# **Safety Evaluation Report**

related to the operation of  
**South Texas Project,  
Units 1 and 2**

Docket Nos. 50-498 and 50-499

Houston Lighting and Power Company

FIGURE 1

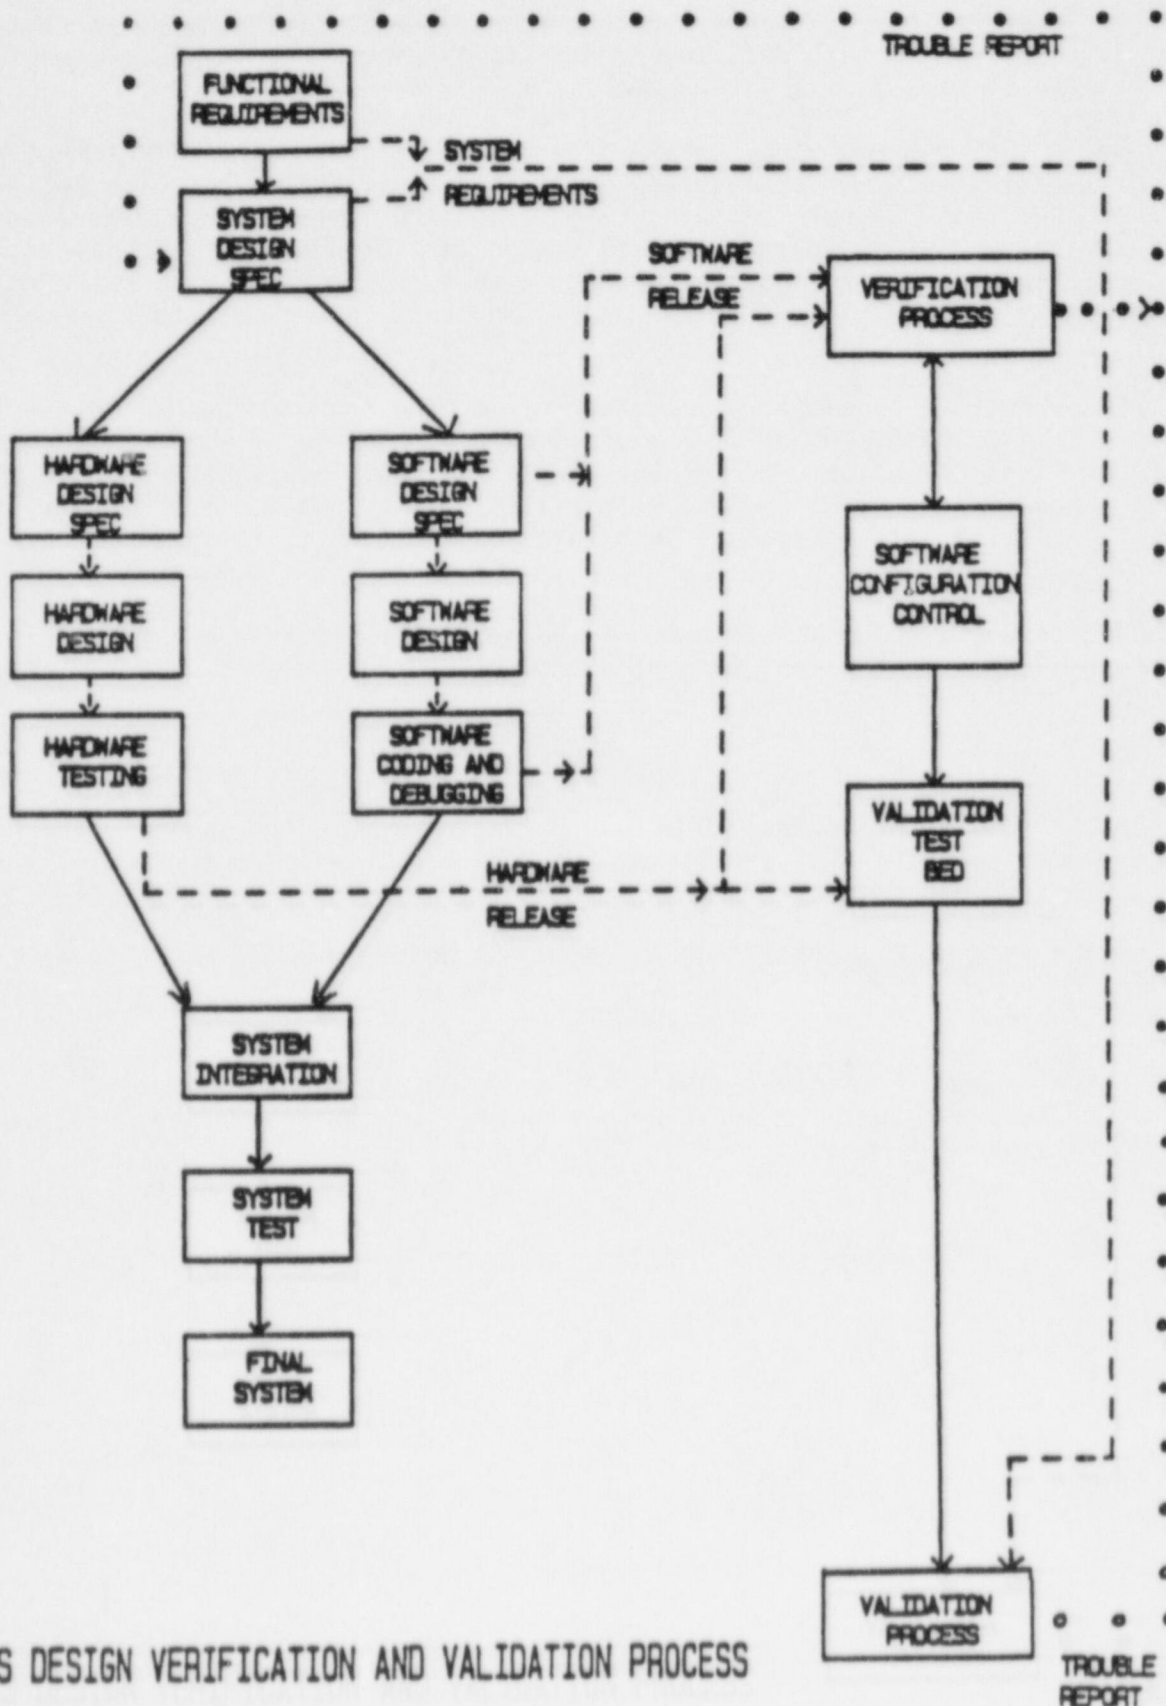
Figure 1 depicts the QDPS design verification and validation process. This figure shows the flow of information from initiation of the functional requirements through system hardware/software design, testing, verification, validation, and initiation/resolution of trouble reports.

- (1) the staff is to review and provide a safety evaluation of the final QDPS V&V report (letter dated December 23, 1986, from M. R. Wisenburg to Vincent S. Noonan).
- (2) After the validation Trouble Reports have been completed, a copy of the summary of all of the Trouble Reports, similar to the verification summary table with summary numbers, should be provided. The applicant and Westinghouse should review each Trouble Report and determine

whether these problems could have been previously found. The staff will review this data and report its findings in a safety evaluation to be issued at a later date.

- (3) A letter needs to be provided by the applicant to the effect that the validation test procedures do not need to be followed to the letter, but that the referenced Factory Acceptance Test (FAT) procedures may be used provided that the validation testing does not accomplish the intended check, and the validation test procedure is more restrictive. The staff will confirm the receipt of this letter in a safety evaluation to be issued at a later date.
- (4) The staff requested a commitment from HL&P to keep the NRC abreast of all troubles encountered and all changes made to the QDPS during the first operating cycle of the plant. This will provide the Staff a basis for evaluating the reliability of the system. The staff will confirm this commitment in a safety evaluation to be issued at a later date.
